Serial No. 10/020,871
Reply to Office Action of July 3, 2006

Docket No. HI-0051

Amendments to the Drawings:

FIG. 1

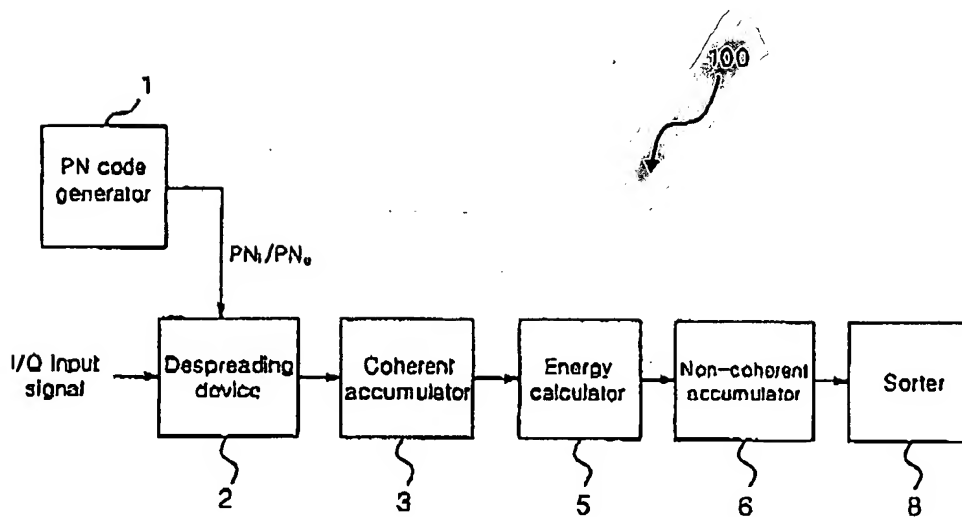
The attached drawings include changes to Figs. 1-3. These sheets, which includes Fig. 1-3, replaces the original sheets including Fig. 1-3. In Fig. 1, previously omitted element 100 has been added. In Fig. 3, previously omitted element 300 has been added.

A. The Office Action objects to Figs. 1 and 3. In Fig. 1, previously omitted element 100 has been added. In Fig. 3, previously omitted element 300 has been added. Attached are Annotated Sheets and Replacement Sheets for Figs. 1 and 3. Applicant respectfully submits the above amendments obviate the grounds for the objection. Withdrawal of the objection to the drawings is respectfully requested.
